NOTICE OF DECISION

REPLAT TENTATIVE PLAN / CLASS 2 ADJUSTMENT CASE NO.: REP-ADJ25-02

LOCATION: 676 17th St SE, Salem OR 97301

IN THE MATTER OF APPROVAL OF
CASE NO. REP-ADJ25-02
676 17th ST SE

PROPOSED RE-PLAT

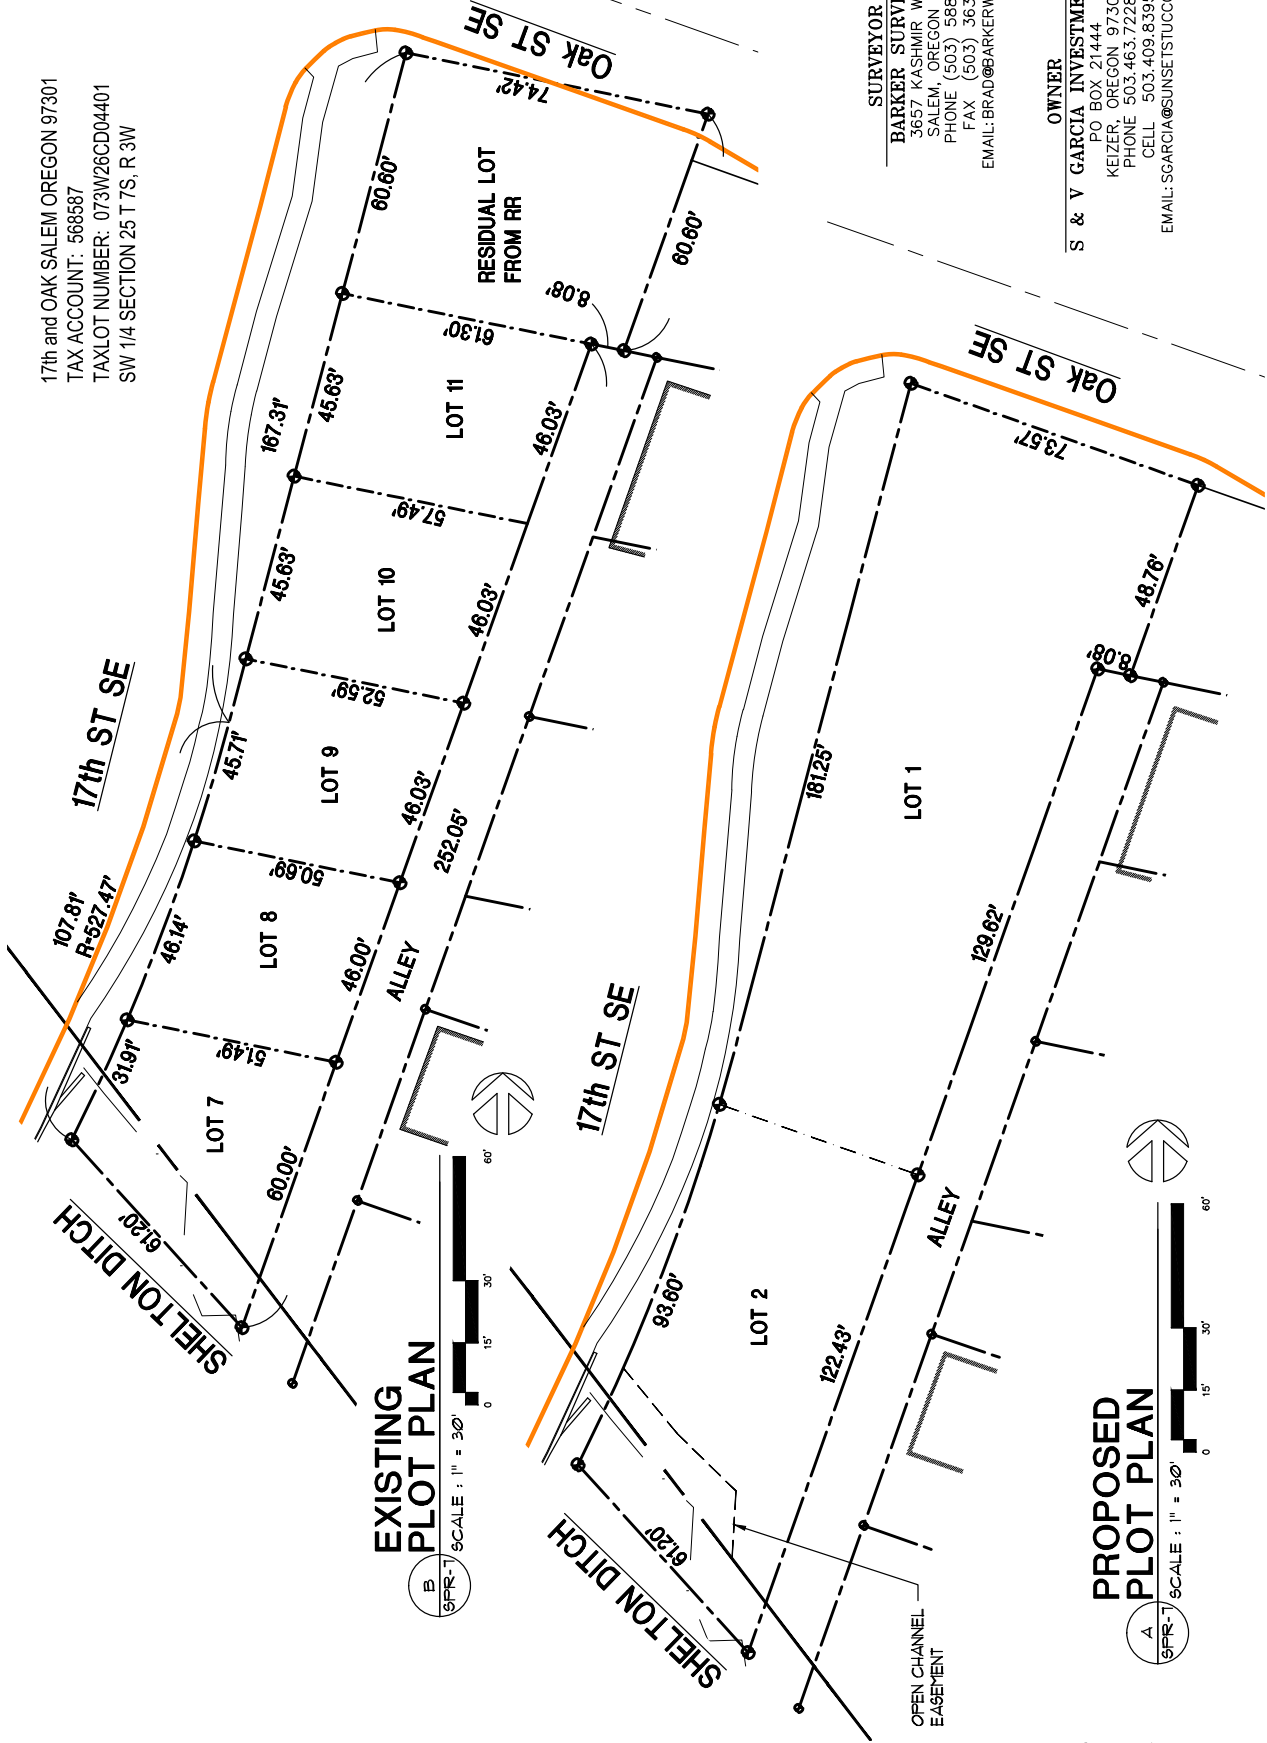
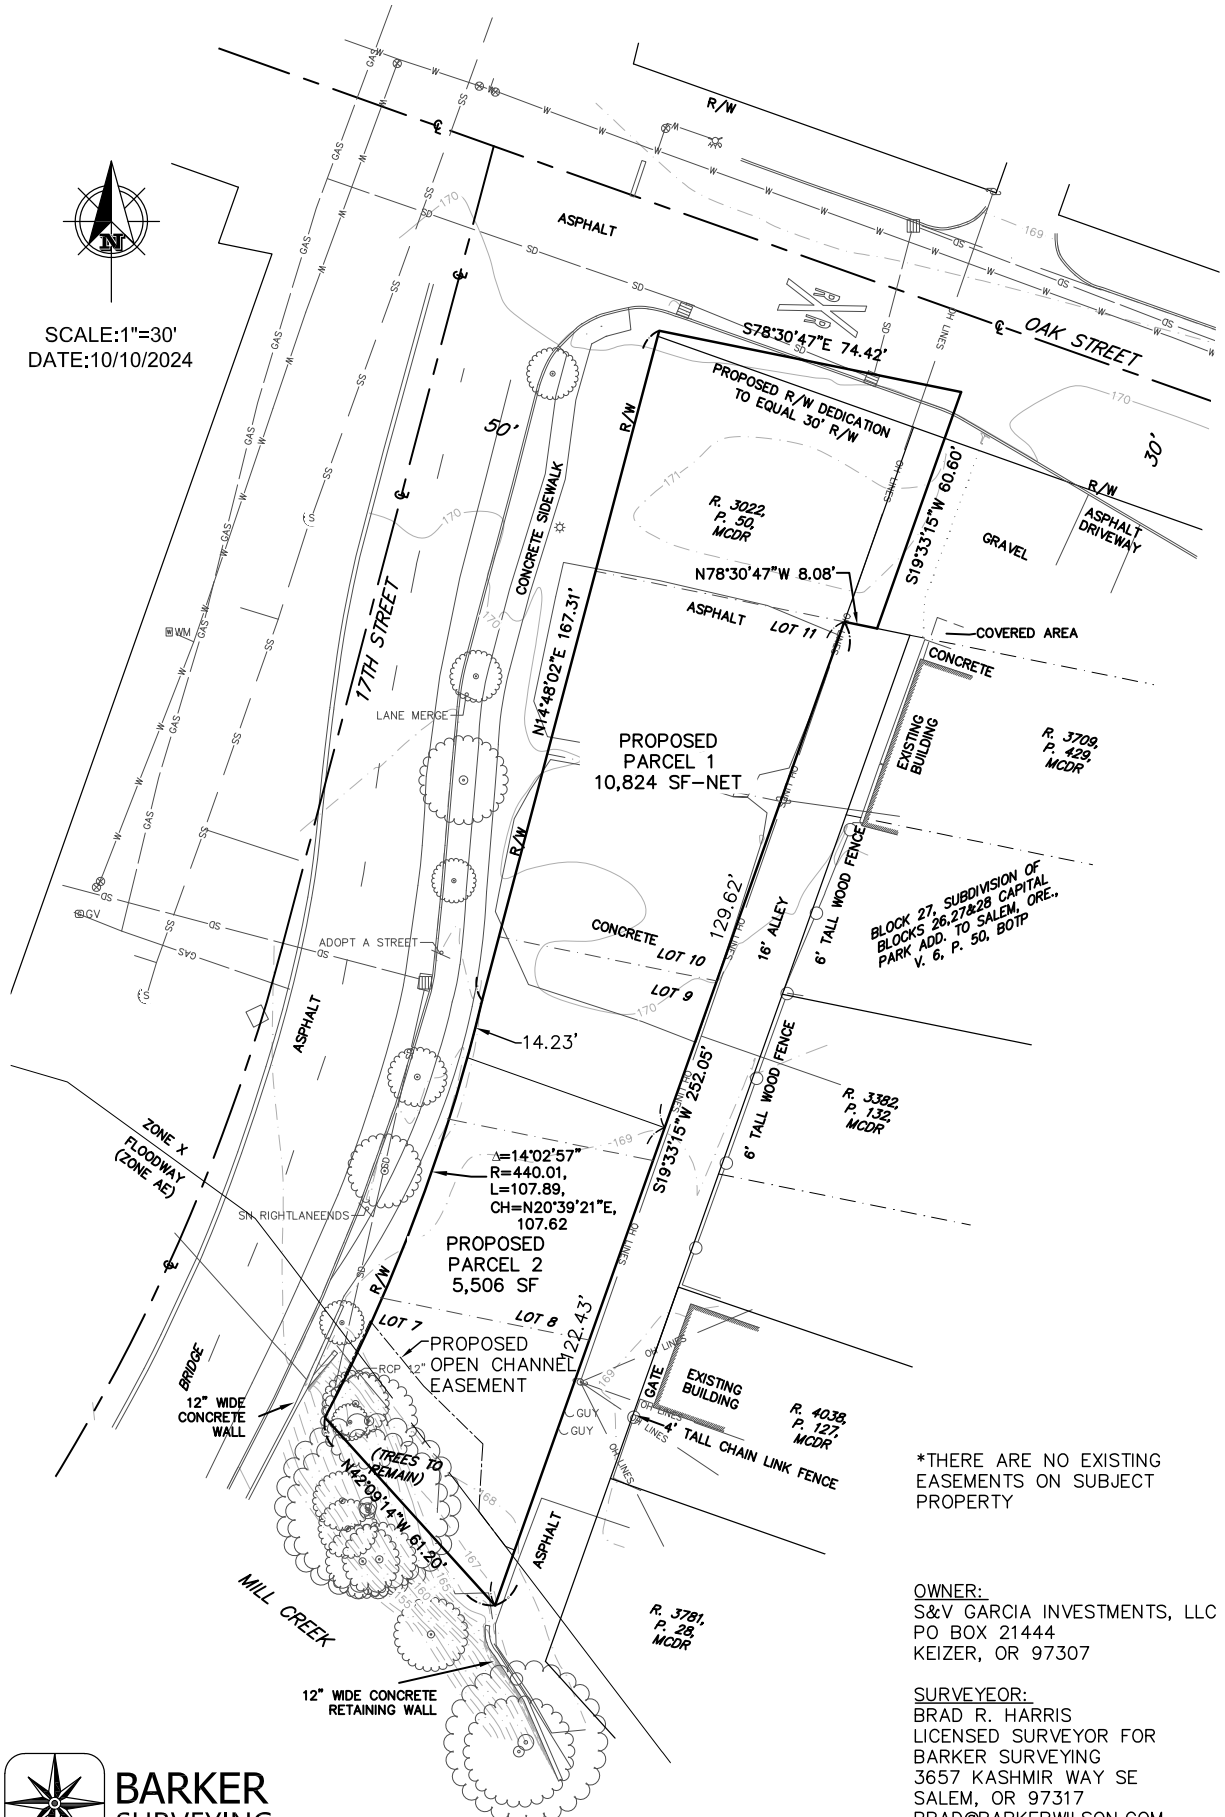
As shown on the replat tentative plan (**Attachment B**), after required right-of-way dedication, proposed Parcel 1 will be approximately 10,824 square feet in size, with 180 feet of street frontage along 17th Street SE, 73 feet of street frontage along Oak Street SE, and will have 58 feet in width and 180 feet in depth, meeting the lot standards of the RM-II zone. Proposed Parcel 2 will be 5,506 square feet, less than the minimum 6,000 square feet, for which the applicant has requested a Class 2 Adjustment. Proposed Parcel 2 will have 93 feet of street frontage along 17th Street SE and will have 107 feet in lot width and 51 feet in lot depth, less than the minimum 80 feet required, for which the applicant has requested a Class 2 Adjustment. The Class 2 Adjustments are addressed in Section 7 of this decision.

As shown on the applicant's utility plans, there are utilities crossing property lines. A private utility easement is required for the water line crossing proposed Parcel 1 to serve proposed Parcel 2. A private stormwater easement is required crossing proposed Parcel 2 for the private stormwater facility on Parcel 1.

The subject property abuts 17th Street SE to the west and Oak Street SE to the north. Direct access for the subject property will not be permitted onto 17th Street SE, the approved site plan (SPR-ADJ-DAP24-27) indicates that vehicle access for the complex will be provided via Oak Street SE and the abutting public alley to the Driveway access to Oak Street is located on proposed Parcel 1, an access easement shall be provided for the benefit of proposed Parcel 2. All necessary access and private utility easements shall be shown on the final plat.

Reduce the minimum lot depth of proposed Parcel 2 from 80 feet to 51 feet, per SRC 514.010(b), Table 514-2.

As described above, due to the narrow north-south orientation of the development site because of past street widening of 17th Street, the applicant has requested a Class 2 Adjustment to reduce the minimum lot depth of proposed Parcel 2. Due to the narrow site constraints of the property and other development standards of the RM-II zone and the multi-family design review standards, allowing a narrower lot depth is necessary to accommodate future development. Because of the street widening, the lot depth could not be met for this

As shown on the applicant's utility plans, there are utilities crossing property lines. A private utility easement is required for the water line crossing proposed Parcel 1 to serve proposed Parcel 2. A private stormwater easement is required crossing proposed Parcel 2 for the private stormwater facility on Parcel 1.

Condition 1: Prior to issuance of a building permit for development on each parcel, the applicant shall submit a revised utility plan demonstrating how each proposed parcel is independently served by sanitary sewer service, water service lines, and water meters as required by SRC 72.091 (Water Service Connections) and SRC 73.065 (Sanitary Service Connections).

Condition 2: Prior to issuance of a building permit for development on the properties which includes a common shared stormwater system, the applicant shall record a Shared Stormwater System Agreement which is in compliance with SRC 802.040.

Condition 3: Prior to final plat, all necessary (existing and proposed) access and utility easements must be shown and recorded on the final plat.
